Patent No.: 7,113,873 B2

For: METHOD AND SYSTEM FOR USING
EDDY CURRENT TRANSDUCERS IN
PRESSURE MEASUREMENTS

REQUEST FOR CERTIFICATE OF CORRECTION OF
PATENT UNDER 37 C.F.R. 1.322(a)

AMENDMENT

- REPLACEMENT SHEET -

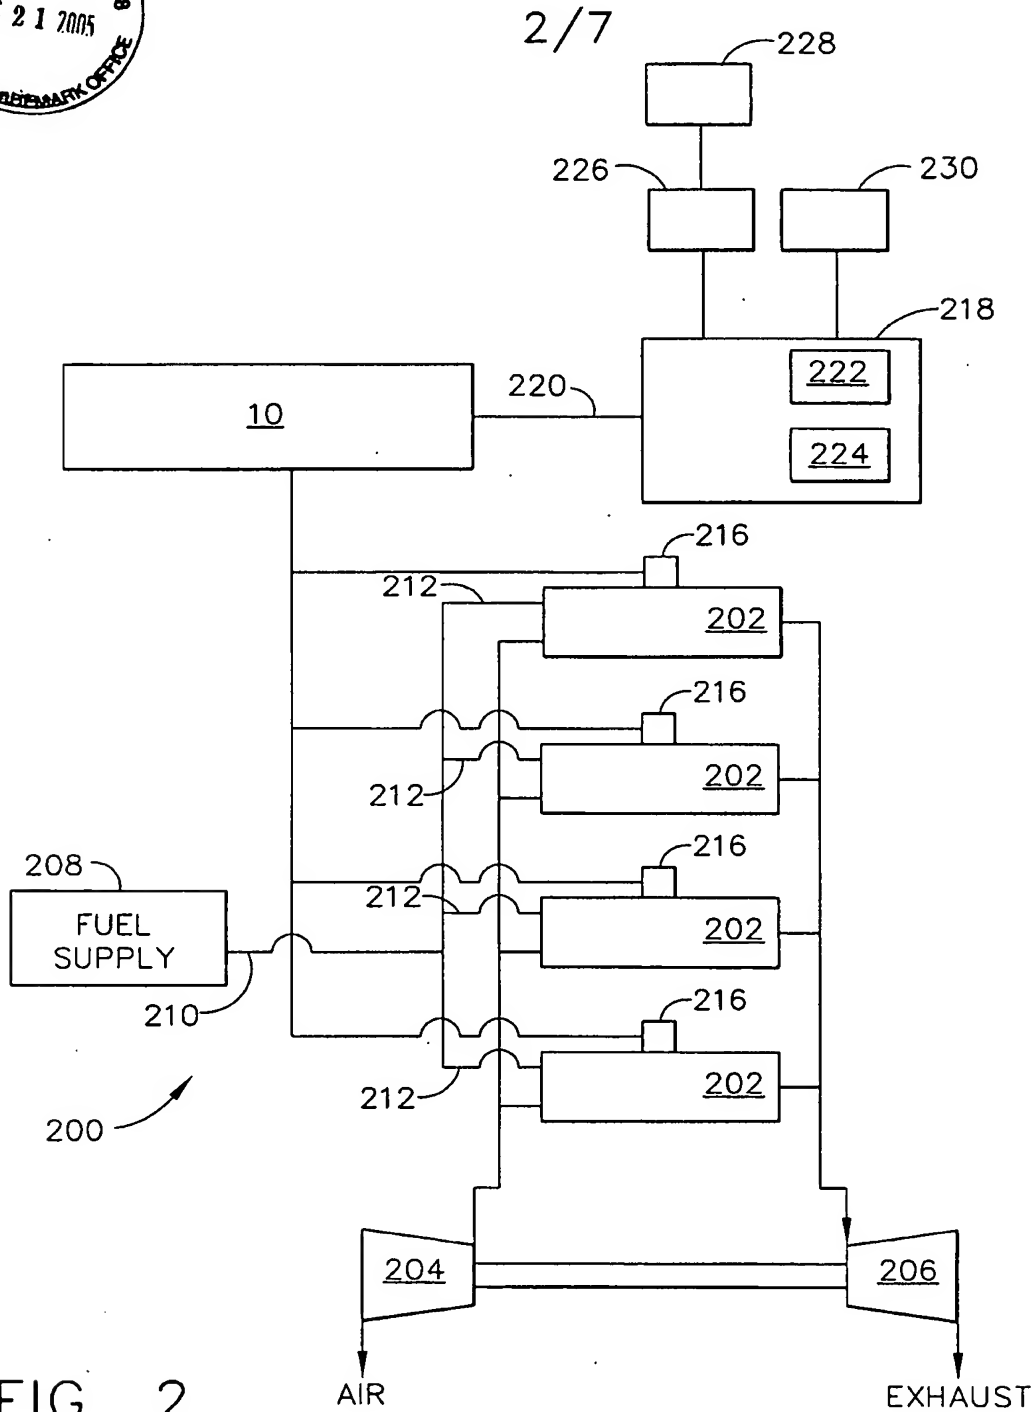
The objections to the drawings under 37 C.F.R. 1.83 (a), is respectfully traversed. Specifically, Figures 1, and 2 have been amended to remove references numbers 82, 86, and 214. No new matter has been added. Replacement sheets for Figures 1 and 2 are attached.
